Re: Proposed Development – Lot 490 Casuarina Way

Please find below responses to comments issued by the New South Wales Department of Planning (DOP) and other relevant agencies in correspondence dated 4 June 2010.

Figure 1. Revised Coastal Hazard Lines provided by Tweed Shire Council 2010

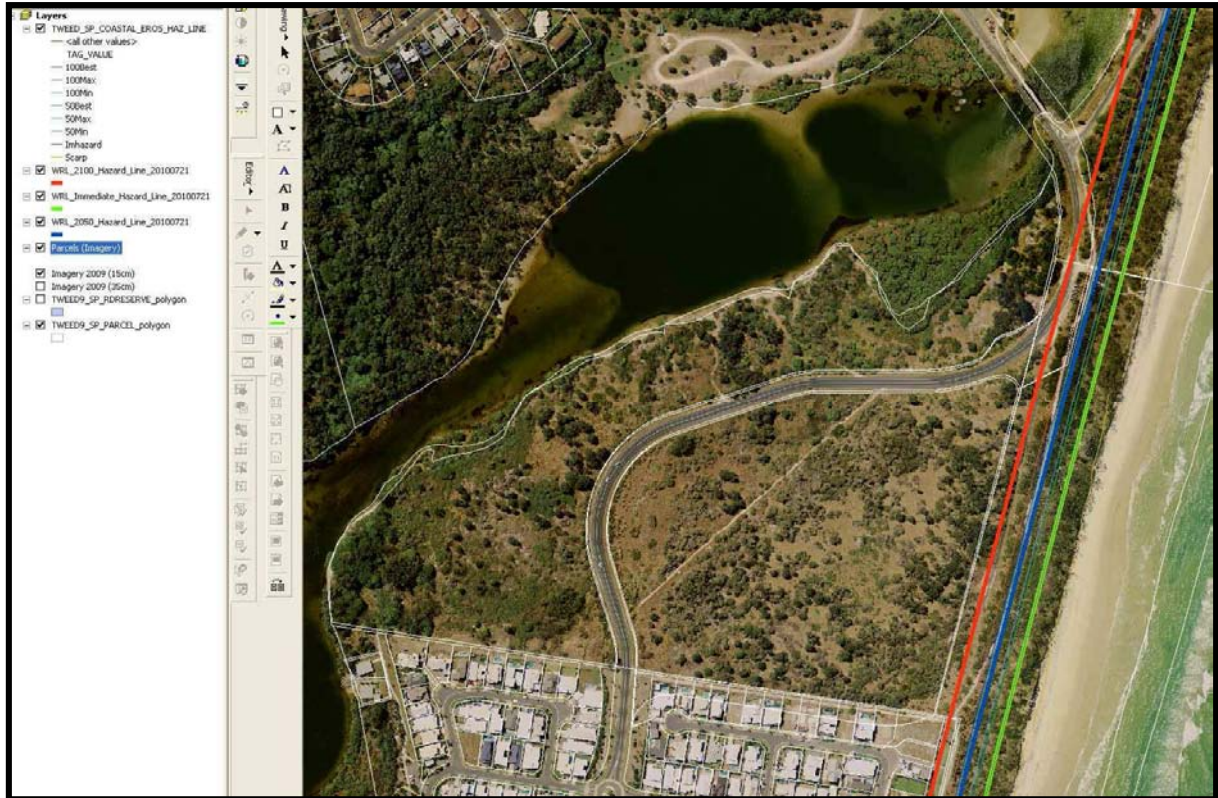
As advised in the DECCW submission the proponent is to further consult with Tweed Council in relation to compliance with minimum requirements for fill and floor levels and coastal hazard impact lines.

Please note we have further consulted with Tweed Shire Council regarding compliance with minimum requirements with respect to fill and floor levels* and coastal hazard impact lines. We have spoken with Jane Lofthouse of Tweed Shire Council on the 21st July, 29th July, and the 4th August regarding revised coastal hazard lines which have been prepared by an external consultant. An image showing the revised hazard lines including an immediate hazard line, 2050 hazard line, and 2100 hazard line was provided by Jane Lofthouse on the 4th August 2010. The revised hazard lines are shown as being further landward than those provided in the previous *Tweed Shire Coastline Hazard Study 2002* (see Figure 1 provided by Jane Lofthouse of Tweed Shire Council below).

We have amended the Coastal Hazard Assessment (attached) so that the revised hazard lines (2010) have been overlaid onto the new development layout. Whilst it is understood the layout has been amended in places response to the comments provided by the Department of Planning and referral agencies amendments were not required for coastal hazard purposes.

It is noted that some public amenities are located seaward of the revised 2100 hazard line (2010), specifically road and car parking, public amenities block, picnic shelters, play ground and circuit training facilities and beach access. Given the non-critical and relatively minor nature of the infrastructure, and that infrastructure is being provided for public use this incursion is considered acceptable provided the balance of Lot 500 is utilised for dune rehabilitation.

FIGURE 4.4 -
OPERATIONAL CONTROL
PLAN

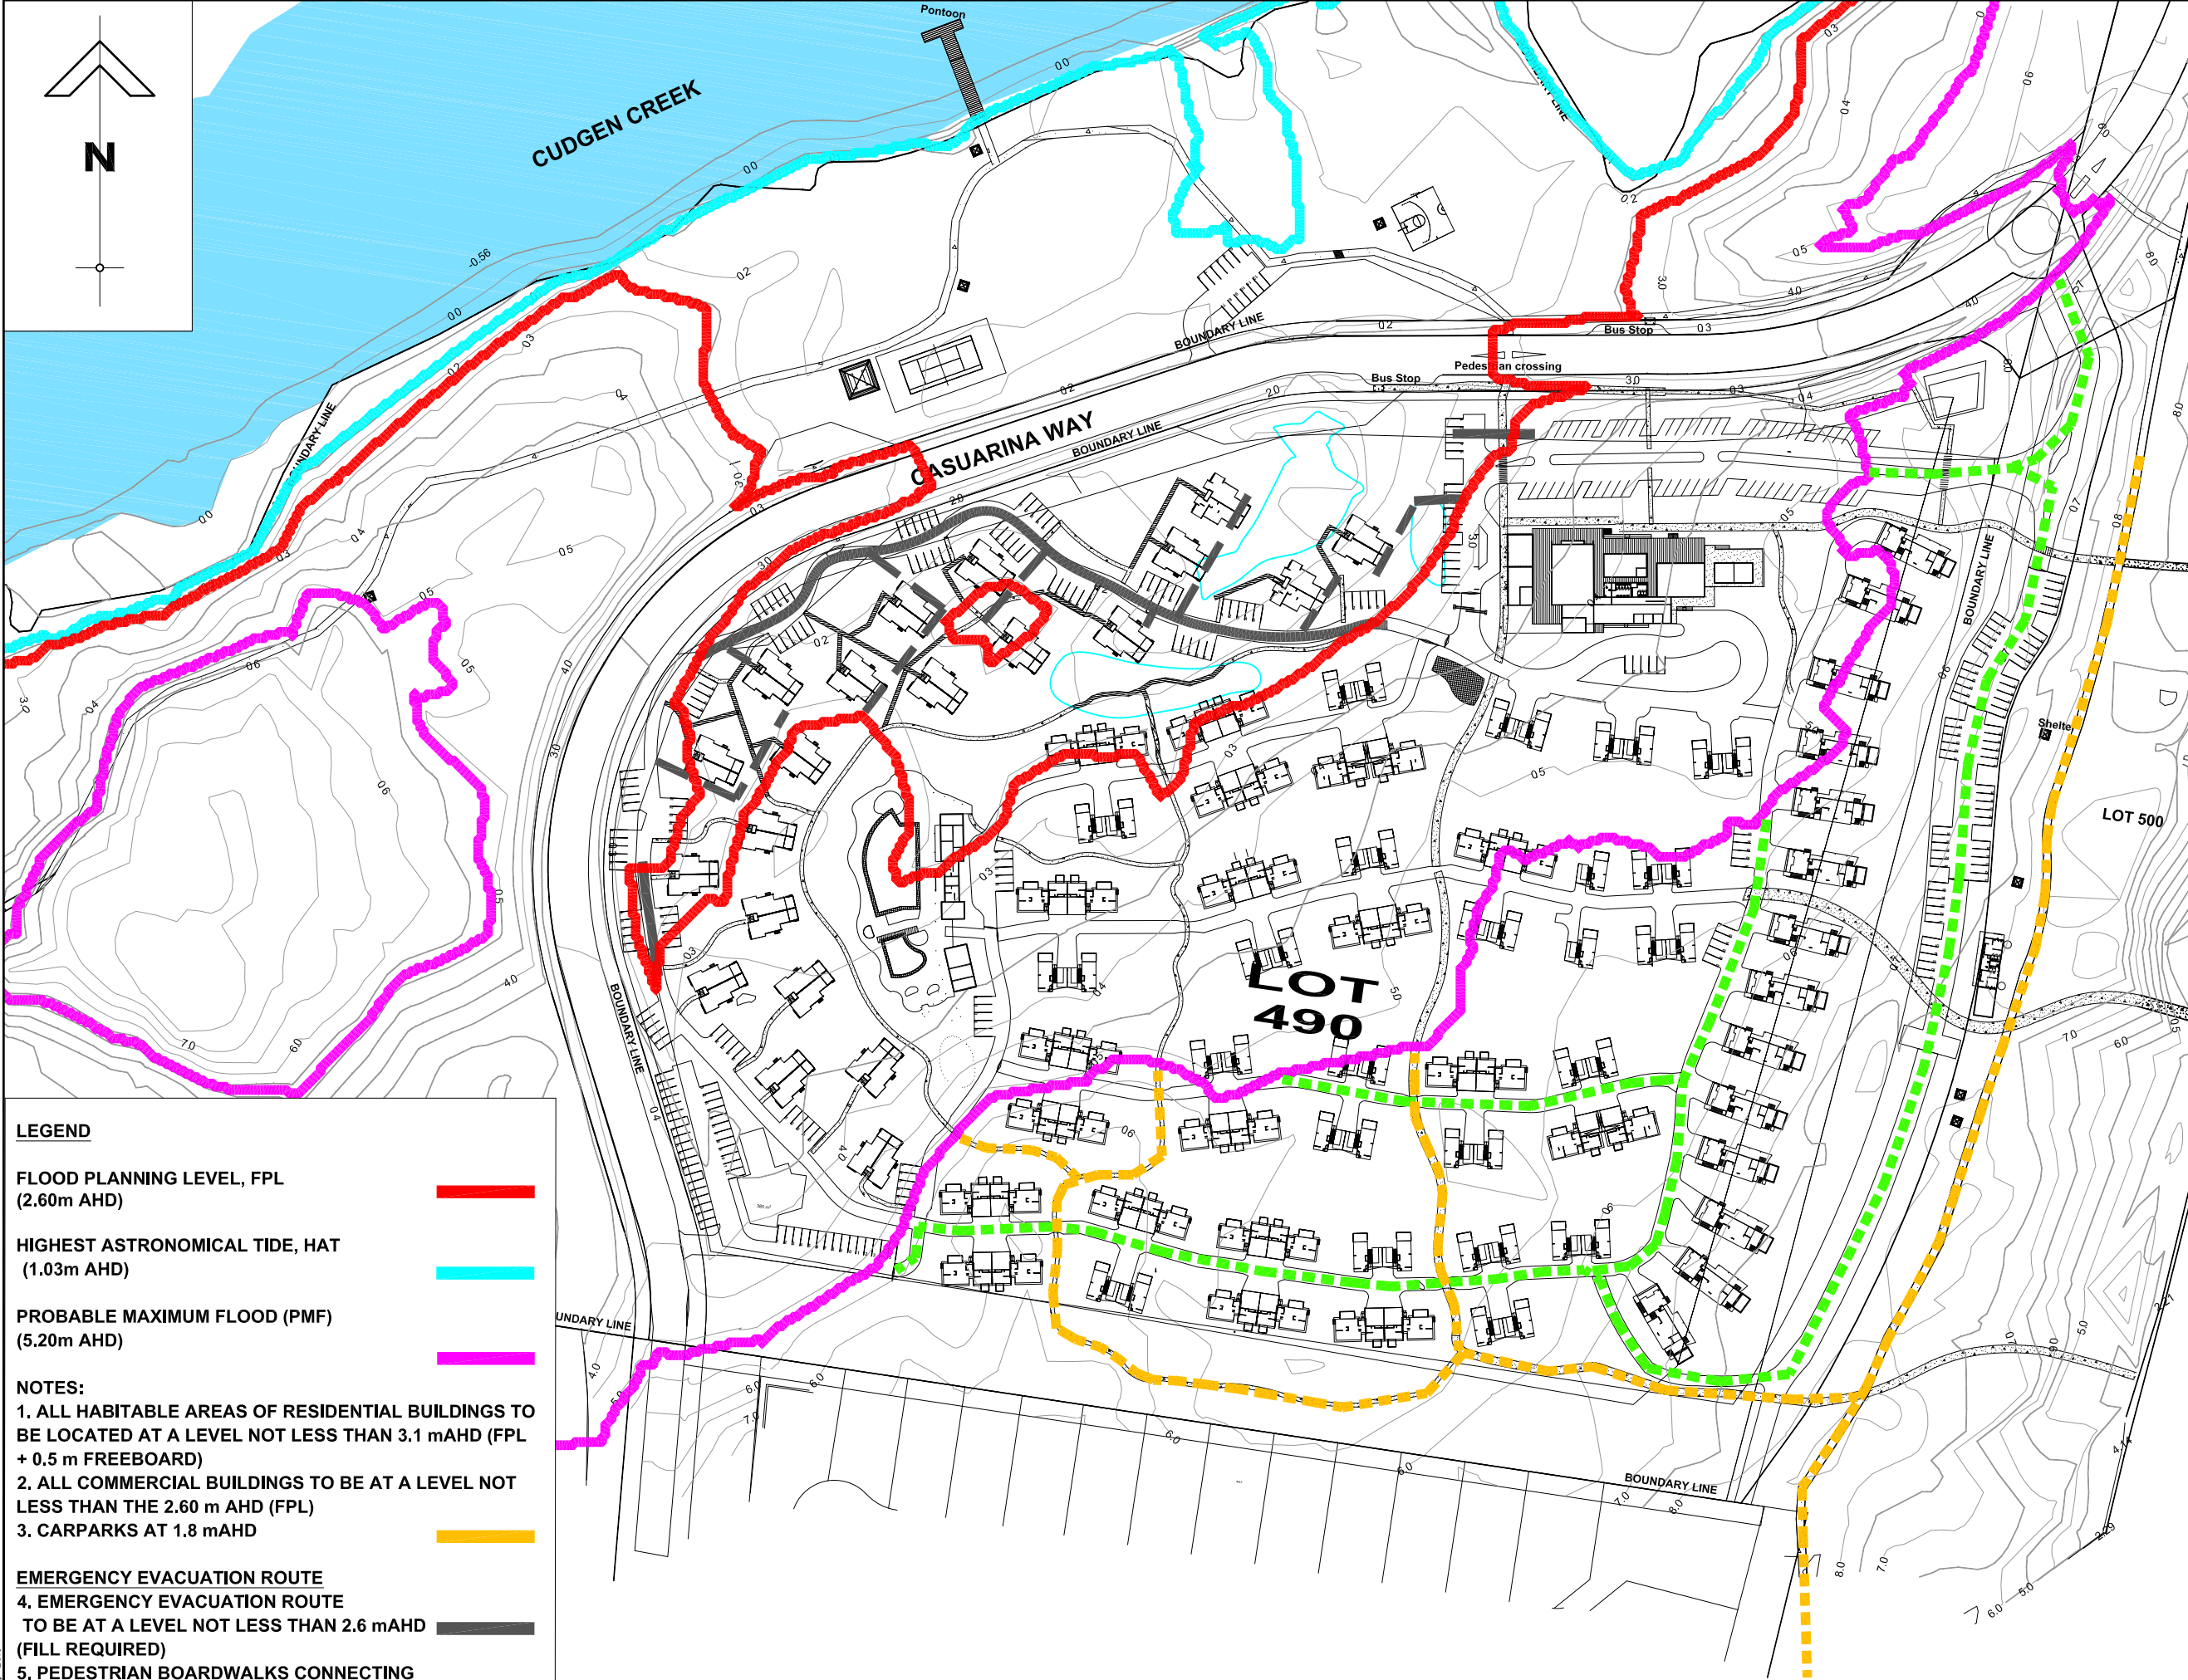
Appendix G 'Stormwater Drainage System Plan' (under 'Infrastructure/Stormwater Management') is inconsistent with Figure 3.3 'Operational Control Concept Plan' (under 'Infrastructure/Stormwater Management'), in relation to the number and configuration of stormwater swales.

Figure 15 'Existing Site Vegetation' in the EA shows an area of Vegetation Community 3, which is representative of the EEC 'Swamp Oak Floodplain Forest of the NSW North Coast, Sydney Basin and South East Corner bioregions' occurring within the Resort Premises (that is, on the eastern side of Casuarina Way). It is not entirely clear how this area will be managed, given its small size and relative isolation. It is noted the 'Stormwater Drainage System Plan' in Appendix G of the 'Infrastructure Provision Report' (Volume 3) shows two stormwater swales draining into this Community. LPMA does not support any proposals that would see concentrated stormwater flows directed towards this or any other EEC.

The Operational Control Plan and Appendix G 'Stormwater Drainage System Plan' have been revised to remove any inconsistencies between the two plans. Please find a copy of both of these plans as an attachment to this letter.

The proposed stormwater system has been revised to ensure the swales do not enter the EEC area. Please refer to the revised Operational Control Plan and Appendix G 'Stormwater Drainage System Plan' included as an attachment to this letter.

We have revised both Appendix G and Figure 3.3 so as they are consistent. Please see attached.

STORMWATER DRAINAGE
SYSTEM PLAN

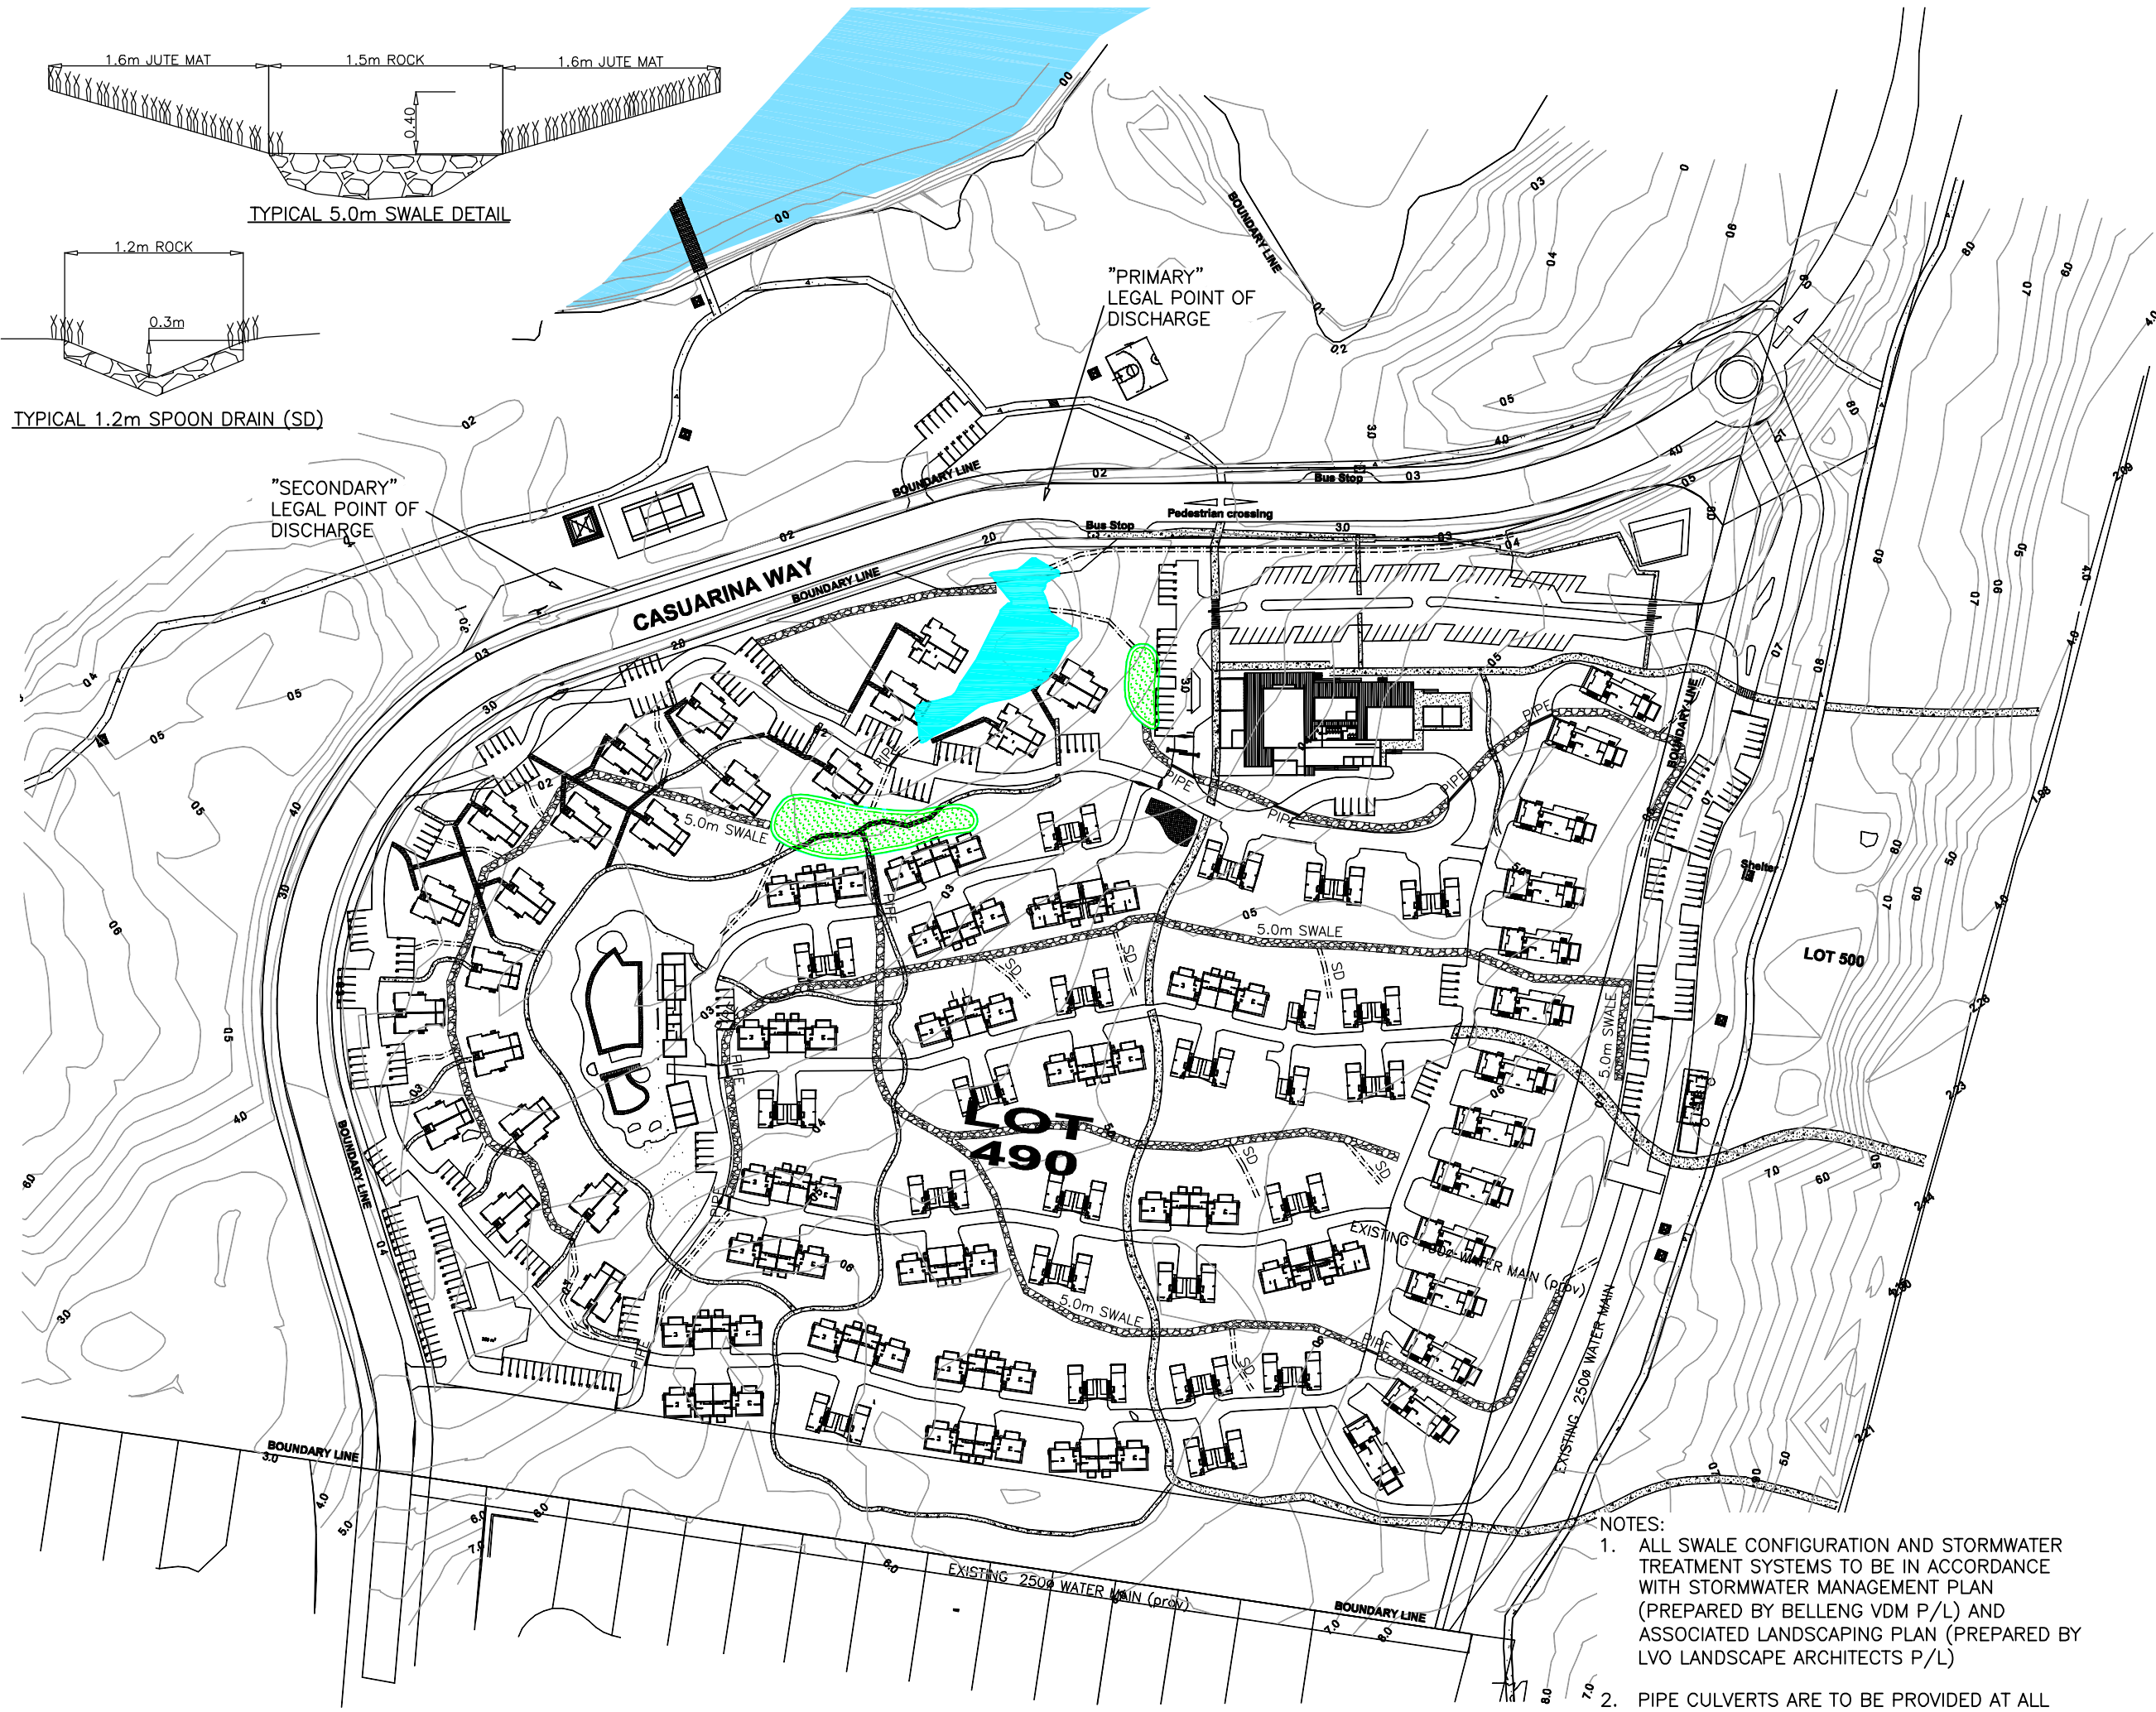
It is unclear how many legal points of discharge exist for the Resort Premises. The ‘Stormwater Drainage System Plan’ (Appendix G, ‘Infrastructure Provision Report’) shows two, but a number of other plans only show one.

Appendix G 'Stormwater Drainage System Plan' (under 'Infrastructure/Stormwater Management') is inconsistent with Figure 3.3 'Operational Control Concept Plan' (under 'Infrastructure/Stormwater Management'), in relation to the number and configuration of stormwater swales.

The “primary” Legal Point of Discharge (LPD) is located at the existing culvert under Casuarina Way at the outlet of the proposed treatment wetland. A “secondary” LPD is provided by another existing culvert under Casuarina Way. However, due to the work to be undertaken on the site and the redirection of flows towards the treatment devices, only a very small portion of the site that remains undeveloped will continue to flow to the “secondary” LPD. The revised Operational Control Plan and Appendix G ‘Stormwater Drainage System Plan’ both indicate the two LPDs.
